Proposal for SAS 2.1 Specification to Enable Support for Active Cables

Gourgen Oganessyan

September 4, 2008

List of Proposed Modifications to SAS 2.0 to Enable Active Cables

Figure 98 — Mini SAS 4x cable plug connector that attaches to an enclosure out, in or universal port

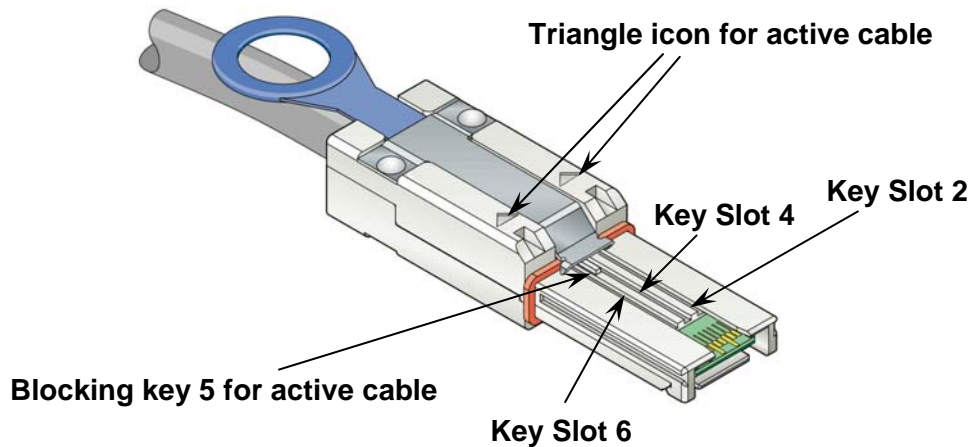
- *Added details of new keying scheme incorporating blocking key in position 5 on the plug and key slots 3 and 5 on receptacle. Updated Figure 98, Table 58 and Table 59 accordingly, added figures 99-101.*
- *Changed the wording in second paragraph of 5.2.7.2.2.1 and second paragraph of 5.2.7.2.2.2 to describe the keying scheme.*
- *Changed the wording of 5.2.7.3.4 from*
“The active cable power supply shall have protection against the connection of the Vcc pin to ground or over-current loading, and shall limit the output current when the supply voltage drops below 2.3 V.”
to
“The active cable power supply shall have protection against the connection of the Vcc pin to ground or over-current loading.”

In order to ensure that active cables are not intermateable with passive receptacles, differentiating keying shall be provided by having key slots in positions 2, 4 and 6 and a blocking key in position 5 on the plug connector, and key slots in positions 3 and 5 on the

receptacle connector in addition to keys 2, 4 or 6 used identify a receptacle for an enclosure out, in or universal port. In addition, two triangle icons on each side on the plug connector shall be added to the plug connector to identify an active cable assembly. The plug connector key positions and icons are summarized in Table 58.

Use	Icon	Key slot positions	Key positions	Reference
End of a SAS external cable that attaches to an end device, or an enclosure out, in or universal port	2 Triangles	2,4,6	5	Figure 98

Figure 99 — Mini SAS 4x active receptacle connector - end device or enclosure universal port

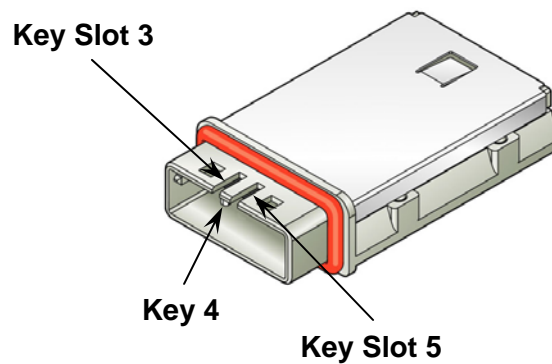
In order to ensure that active cables are not intermateable with passive receptacles, differentiating keying shall be provided by having key slots in positions 2, 4 and 6 and a blocking key in position 5 on the plug connector, and key slots in positions 3 and 5 on the receptacle connector in addition to keys 2, 4 or 6 used identify a receptacle for an enclosure out, in or universal port. In addition, two triangle icons on each side on the plug connector shall be added to the plug connector to identify an active cable assembly. The plug connector key positions and icons are summarized in Table 58.

Use	Icon	Key positions	Key slot positions	Reference
End device or enclosure universal port	2 Triangles, Diamond and a Circle	4	3, 5	Figure 99
Enclosure out port (see 4.6.2)	2 Triangles and a Diamond	2	3, 5	Figure 100
Enclosure in port (see 4.6.2)	2 Triangles and a Circle	6	3, 5	Figure 101

Figure M.1 — Dual comparator design for active cable detection

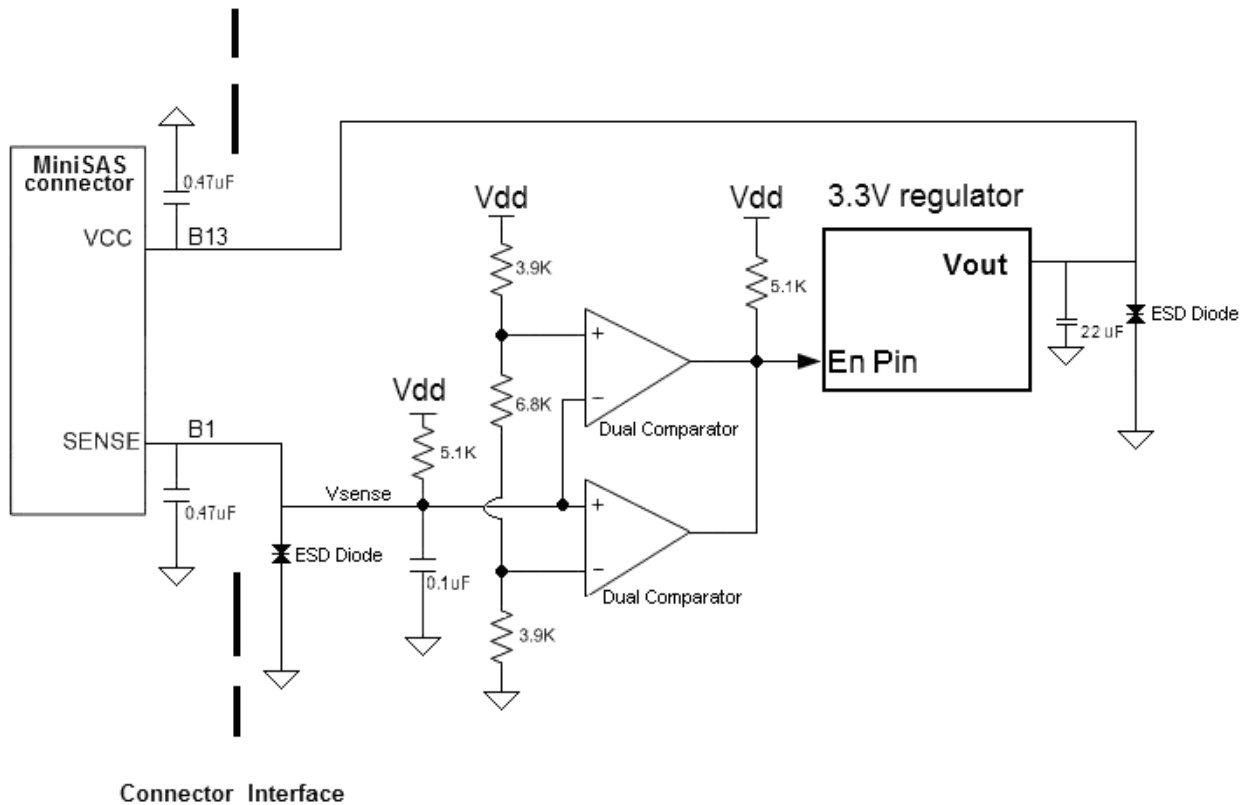
- *Added a proposed Informative Annex M for power supply logic reference design.*

- *Edited most of the wording throughout the document to conform to the T10 style guide and to incorporate comments received from the group*
- *Deleted the minimum value for Supply Current in Table 61 and changed the maximum value from 600 mA to 319.4 mA.*
- *Edited the Informative Annex M to conform to the T10 style guide, dropped Table M.1 (parts List) and edited Figure M.1 to identify the function of the components.*

- *Title and other references to the specification is now 2.1 instead of 2.x*
- *The pinout of active mini SAS cables has been changed in Table 60: the Sense pin is now B1 instead of B10, and pin B10 reverts to ground. The change is also reflected in Figure M.1 of Annex M.*

Fig M1 is an example design utilizing a dual comparator to determine from the sense pin on the active cable plug if an active cable is in operation. The circuit then supplies power based upon whether there is an active cable connected to the receptacle.
